The Corporation of the
City of Burlington

EVALUATION OF HALTON REGION LANDFILL TECHNICAL STUDIES

Site D - Milton

DESIGN AND OPERATIONS REPORT

figure B2.1
TROW - HYDROGEOLOGIC DESIGN CRITERIA
SITE "D" - DESIGN AND OPERATION
City of Burlington

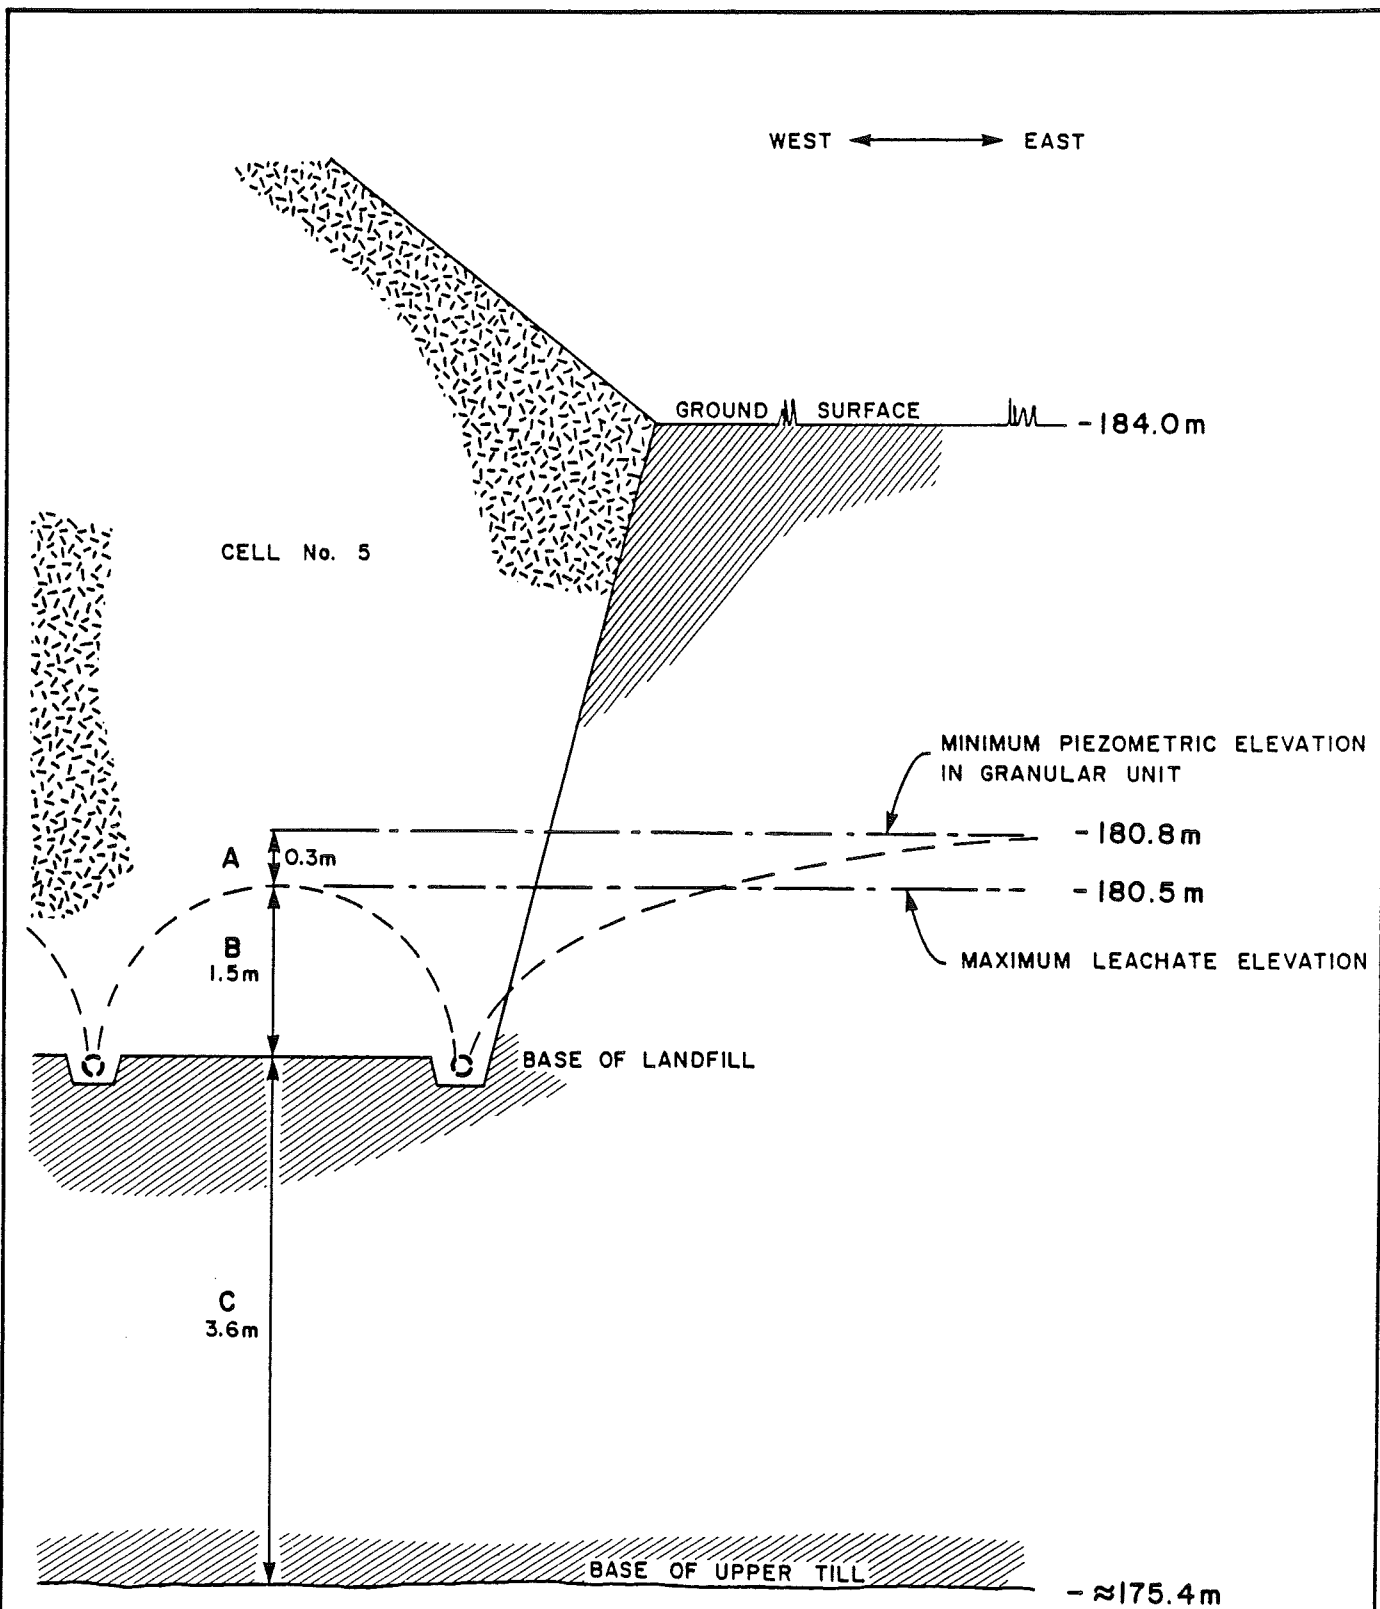
The information presented in Table B.2.1. (page 37), along with all elevation information taken from Plan 1, allow an assessment of the Trow design's adherence to the two design objectives of maximizing the till thickness and maintaining a 0.4 m differential between the maximum leachate elevations and the minimum April 1986 piezometric elevation. This assessment is summarized in Table B.2.2 (page 38). To assist in understanding the table, Figure B.2.1 (page 39) provides a cross-sectional illustration of Cell No. 5.

- 1) "Maximum Base of Upper Till" (see Table B2.1, page 37).
- 2) "Base of Landfill from Trow Drawing No.2, Exhibit H-41.
- 3) "Maximum Leachate Level" is highest elevation of base of landfill plus leachate mound of 1.5 m.
- 4) "Design Piezometric Elevation" is equal to the lowest measured piezometric elevation in strata below the upper till, as measured in April 1986 (see Table B2.1, page 37).
- 5) "Minimum Upper Till Thickness" is the difference between the maximum base of the Upper Till and the minimum base of the landfill.
- 6) "Minimum Hydraulic Trap Head" is determined by subtracting the "Maximum Leachate Level" from the "Design Piezometric Elevation". A value less than 0.4 m under "Minimum Hydraulic Trap Head" implies that the trap design criteria has not been met.

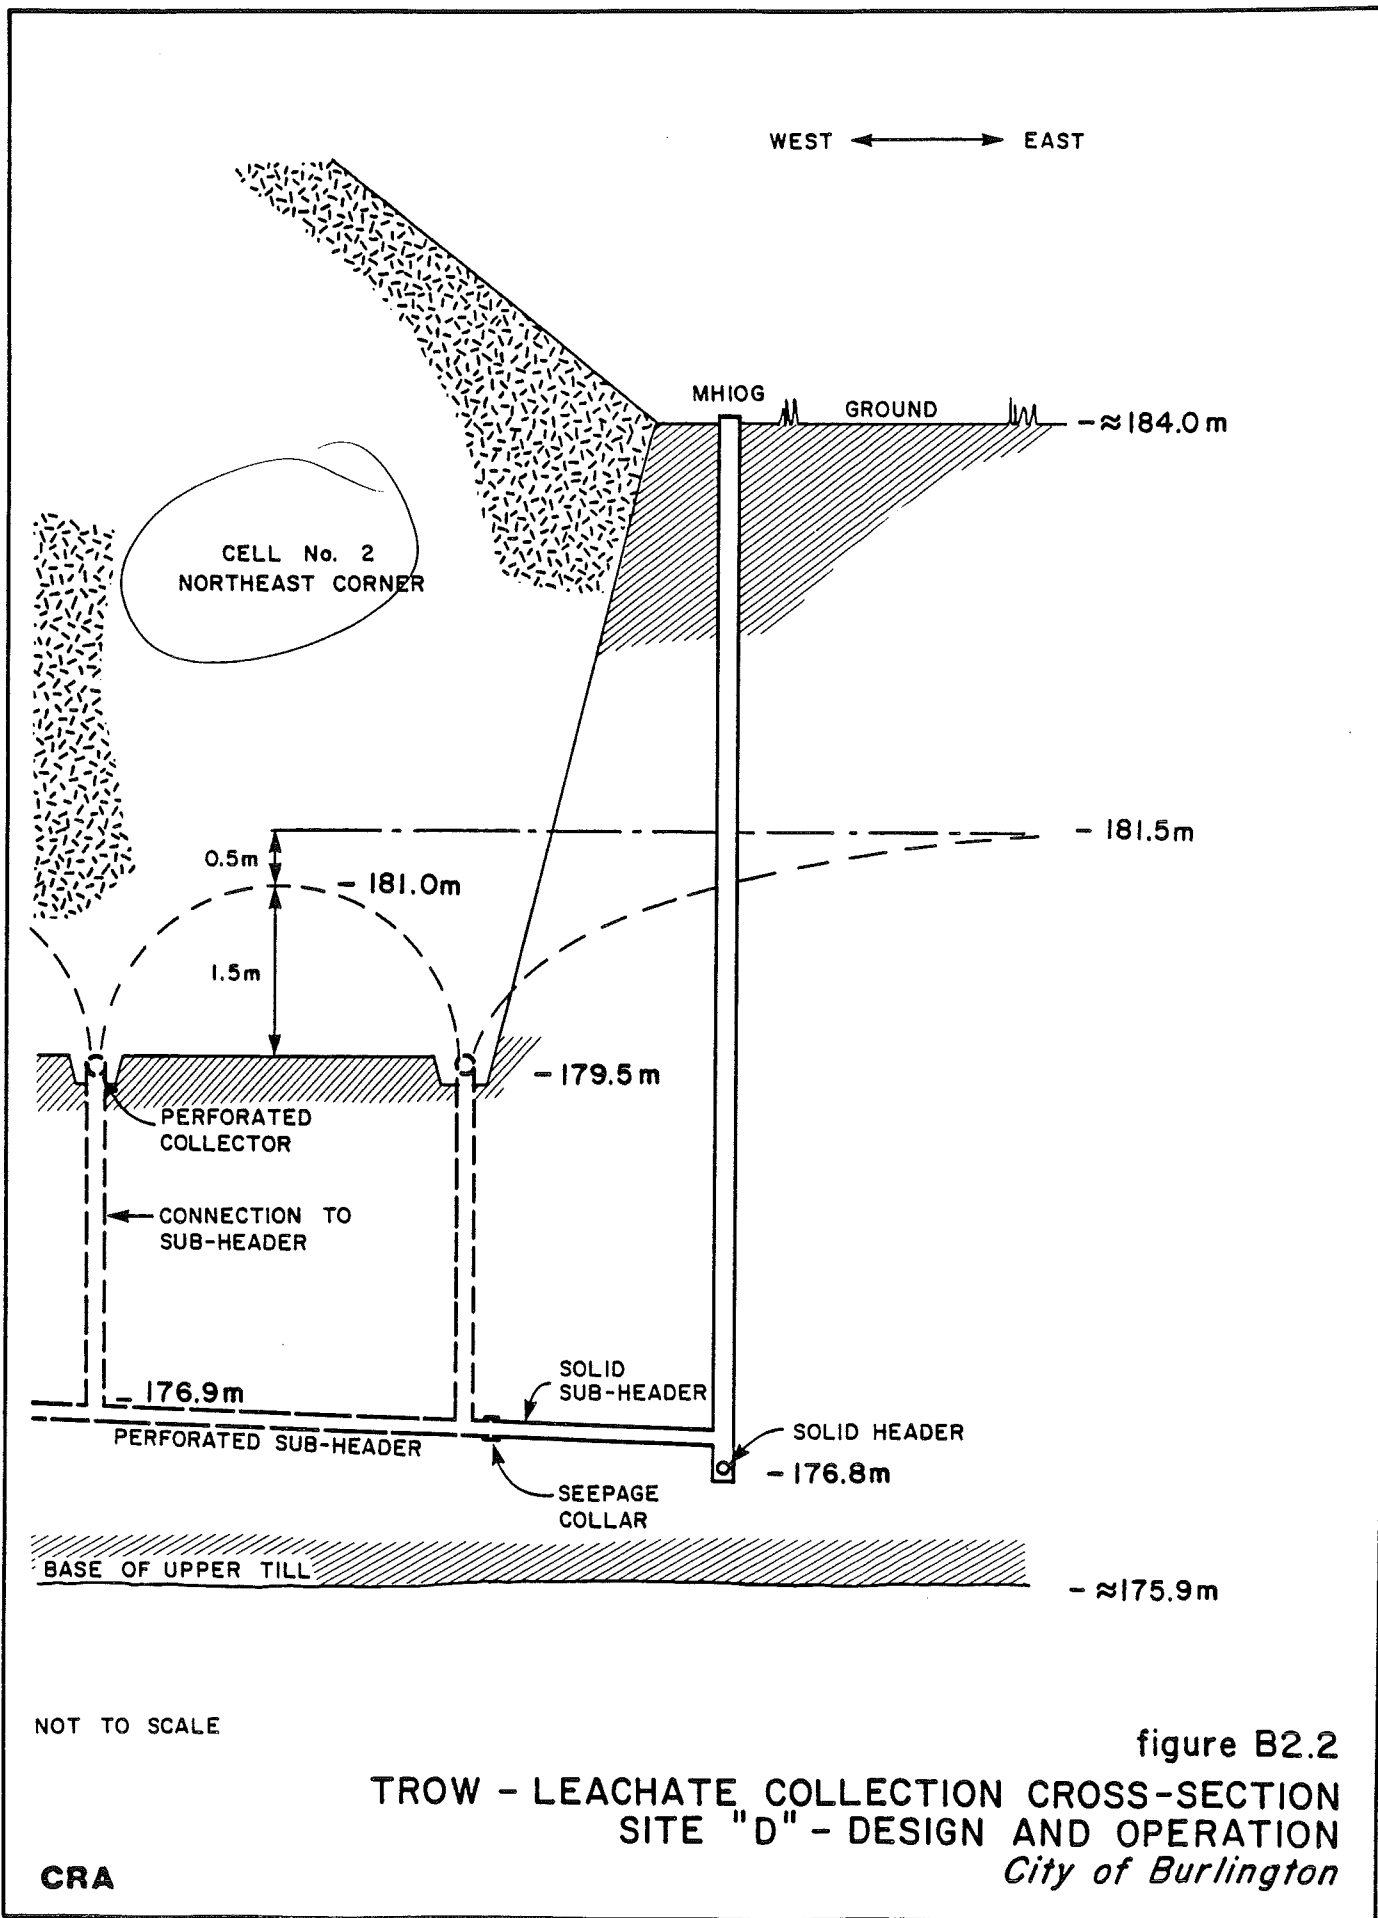
To assist in the review, Figure B.2.2 (page 44) was developed to provide a typical cross-sectional view of the leachate collection system. In addition, the base elevation of each subheader and header manhole are plotted on Plan 1.

Based on the leachate collection system design criteria and the design illustrated in Plan 1 and Figure B.2.2 (page 44), the following were noted:

figure C3.2
CROSS-SECTIONS OF ALTERNATIVE DESIGN
SITE "D" - DESIGN AND OPERATION
City of Burlington

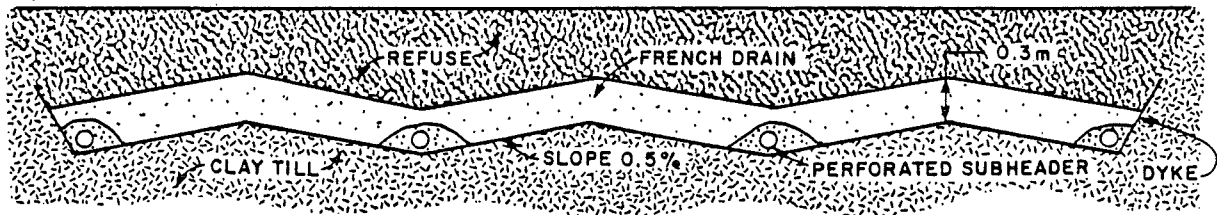
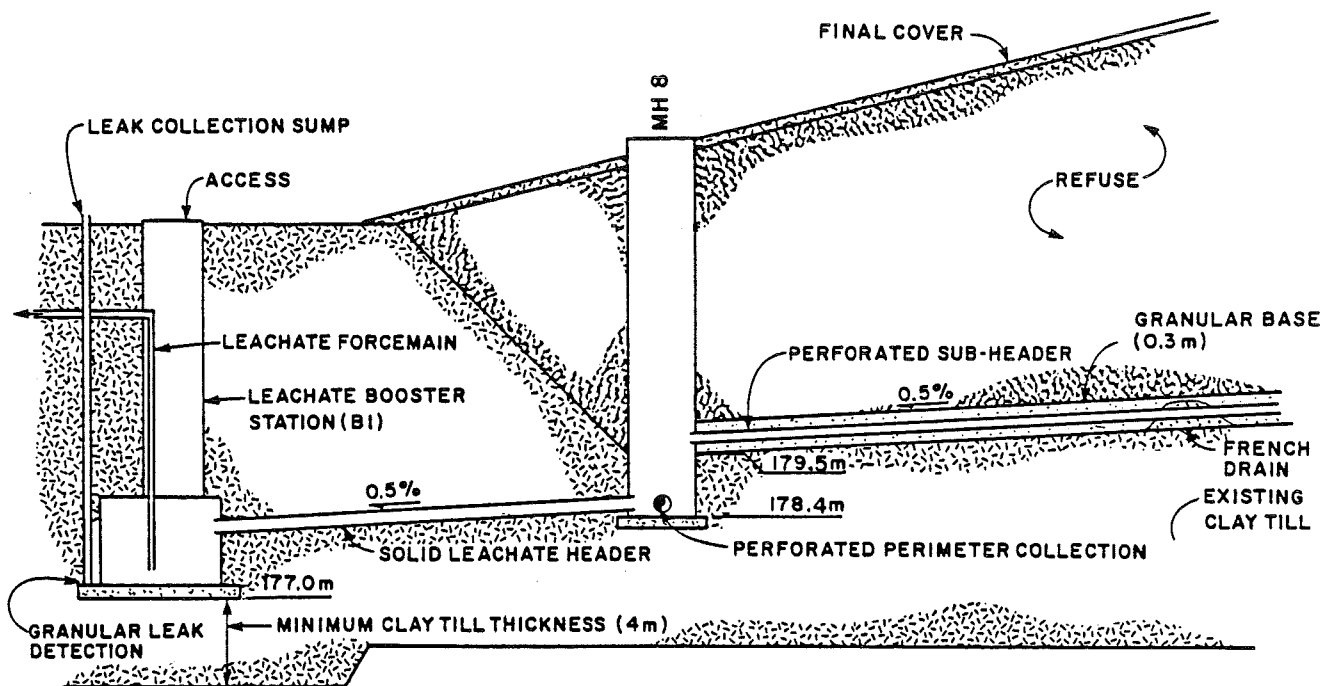
Figure C3.1 (page 61) illustrates a typical cross-section of the landfill design. Denoted in the Figure are the letters A, B and C. As described in Section A.3.2, the letter "A" denotes the inward gradient which provides the hydraulic trap, the letter "B" denotes the leachate mound, and the letter "C" denotes the thickness of the Upper Till unit remaining below the base of the site. At any given location, the total of A, B and C represents a fixed sum. Within any of the three cells, the magnitude of A, B and C can be adjusted to optimize conflicting design and balance objectives such as maximizing the hydraulic trap head (A),

figure C4.1
 PROPOSED LEACHATE FORCEMAIN/ SEWER
 SITE "D" - DESIGN AND OPERATION
 City of Burlington

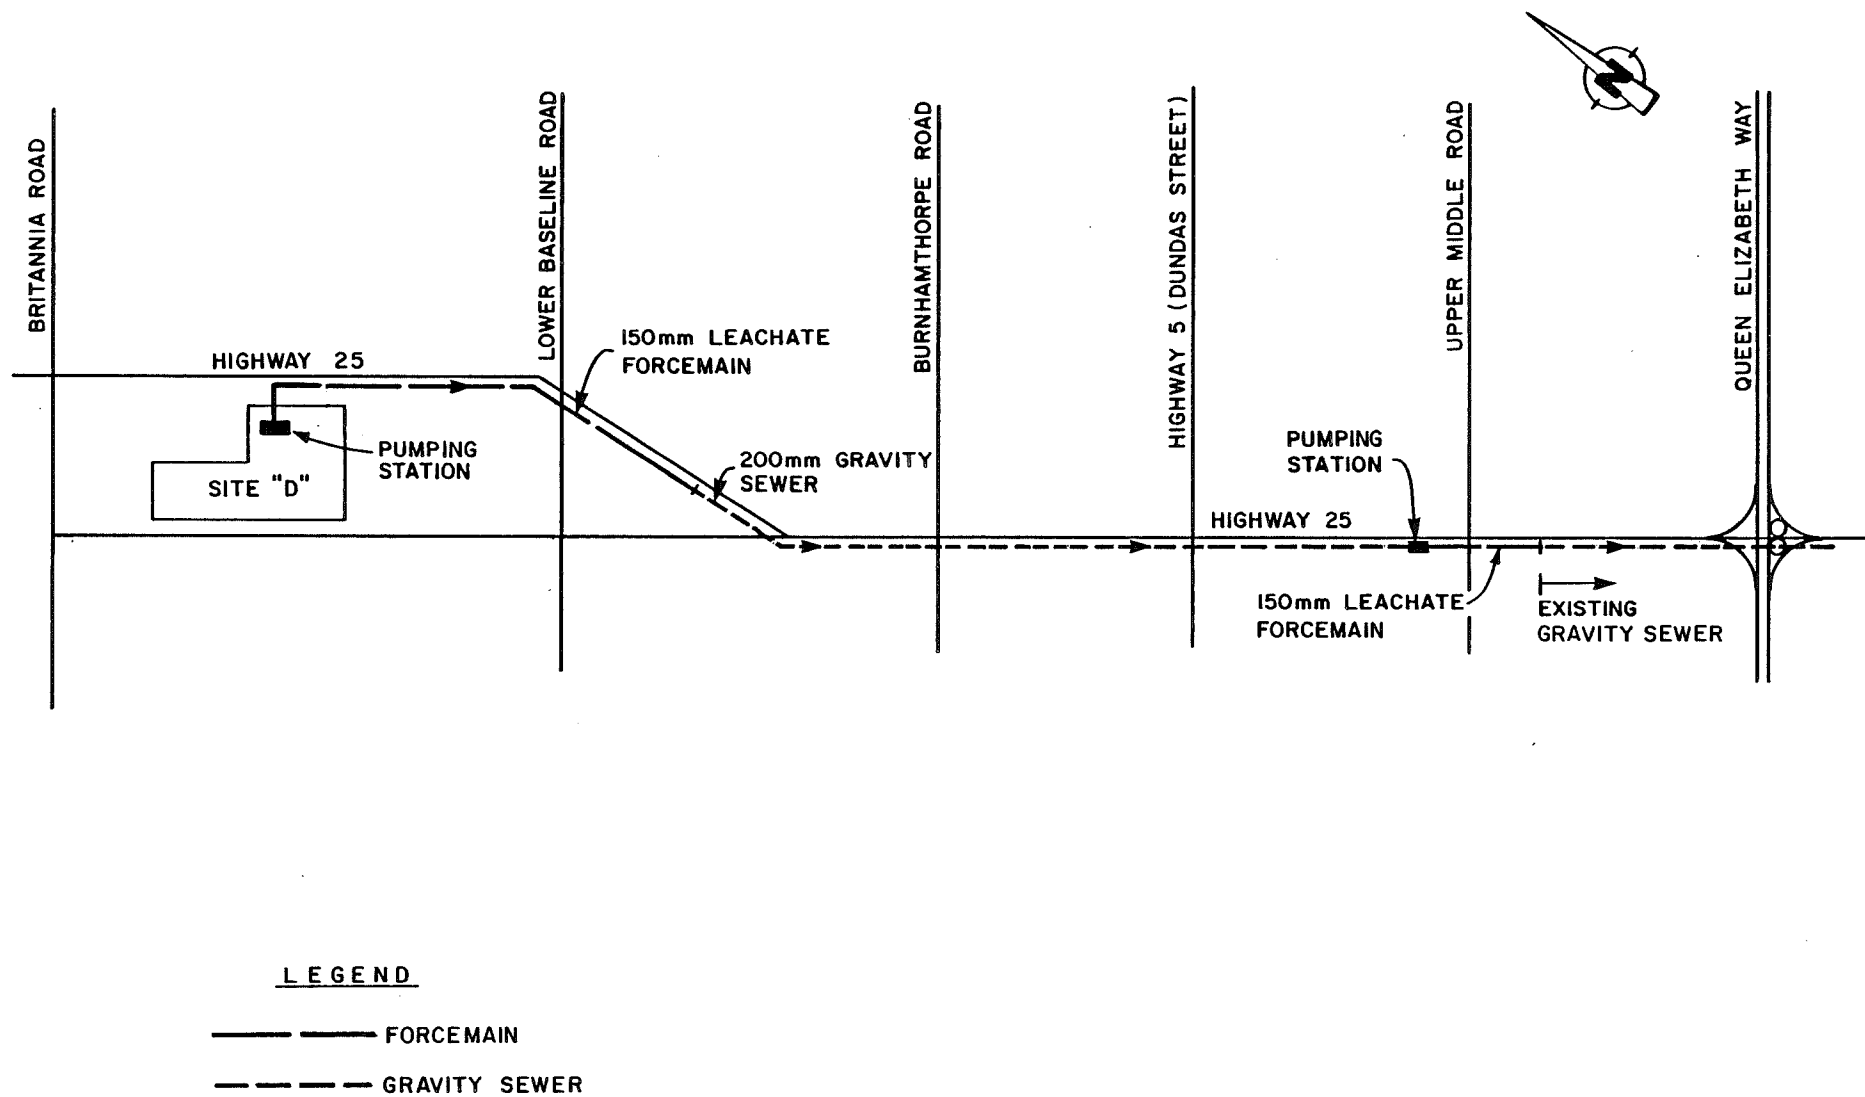
In light of the cost of long term hauling and the concerns with the provided sewer/forcemain design, it is recommended that the feasibility of the sewer/forcemain be evaluated in some detail, and the economics of the sewer/forcemain be compared to the economics of long term hauling.

As illustrated in Figure C4.1, it is proposed to construct a 150 mm forcemain from Site D to a high point of land approximately one kilometre south of Lower Baseline Road.
